MEMORANDUM

SUBJECT: Review of Architectural Details Associated with Conditional Use Permit 21-005; Construction of a New Commercial Building And Establishment Of An Art Gallery And Wine Tasting Collective Location: 211 E. Branch St; Applicant: Eric and Jill Von Berg; Representative: Jennifer Martin

DATE: February 7, 2022

Figure 1: Revised Site Plan

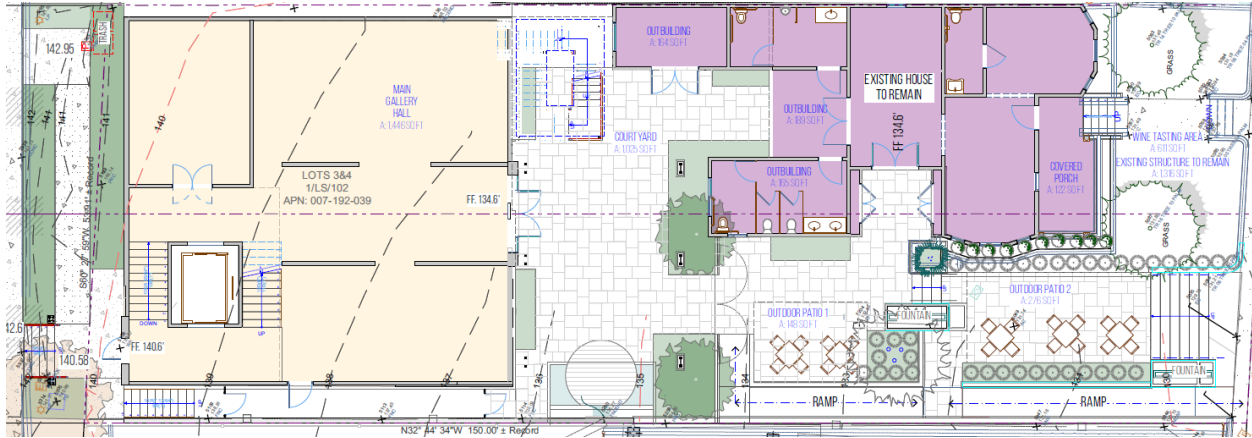
Projects are encouraged to retain as much landscaping as possible, and when infeasible, incorporate street trees and sidewalk planters to liven the streetscape. Robust landscaping is proposed throughout the site. Citrus and olive trees are proposed on both on-grade and on the rooftop deck. Climbing vines are proposed to cover the on-grade trellis and planter boxes around the perimeter of the rooftop deck. Two water fountains and the koi pond included in the original design are proposed to remain. These fountain water features add up to approximately 125 square feet of water surface. Water usage for these elements is approximately 4,300 gallons per year. By comparison, the same size area of turf or densely planted ornamentals with spray irrigation would use approximately 4,900 gallons per year.

Figure 2: Proposed grading

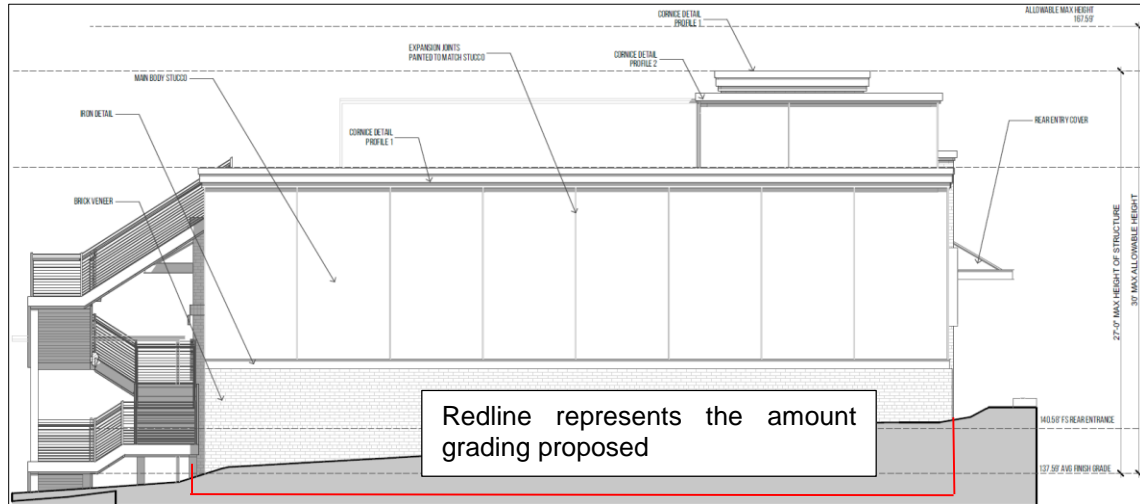
Grading associated with the project will reduce the elevation of the finished grade by as much as seven feet in some areas below the existing grade. In addition to making the site more functional and buildable, the reduced elevation will obscure the visibility of the proposed structure. Another benefit of the grading is that it will reduce the perceived height of the structure compared to if such substantial grading was not proposed.

Figure 9: Brick veneer on the west elevation breaks up stucco wall and again creates a cornice.

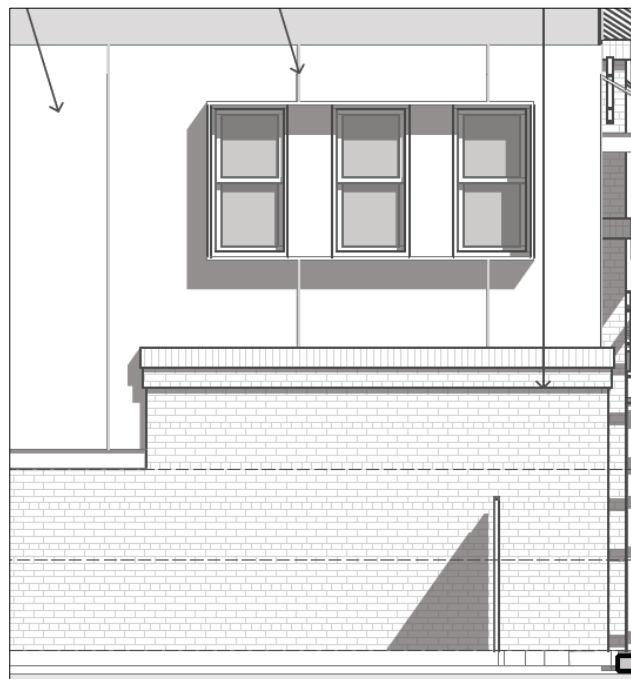
The proposed structure uses stucco as the primary cladding material and brick veneer as a secondary material. The stucco is proposed to have a hand-troweled, smooth finish and staff is also recommending a uniform or very close to uniform color to provide a more cohesive traditional theme. The building design proposes metal expansion joints, dark iron wainscoting, and cornices to add the ornamentation required to comply with the Design Guidelines. Brick veneer is proposed as a complementary material and serves multiple purposes. It adds color and texture to the west and east elevations to avoid an expanse of stucco. Detailed brickwork on the north and south elevations near the entrance areas creates areas of relief and shadowing. Brick is also used to create a cornice detail on the north, south, and west elevations. Stucco and brick, both on their own and in combination, have been successfully implemented on other structures in the Village. Staff is recommending that the iron wainscot be replaced by brick because brick is noted as a material that accentuates the historic character.

1. Reduce the size of the rooftop trellis. The trellis shall be a minimum of fifteen feet (15') from the southern edge of the building.
2. Add variation and ornamentation to the roofline consistent with the Village character.
3. Replace the iron wainscot detail with brick.
4. Use a consistent window size.
5. Revise the color palette to be more uniform and modify the stucco color to better complement the existing structure
6. Use light fixtures consistent with the historic period of the Village.
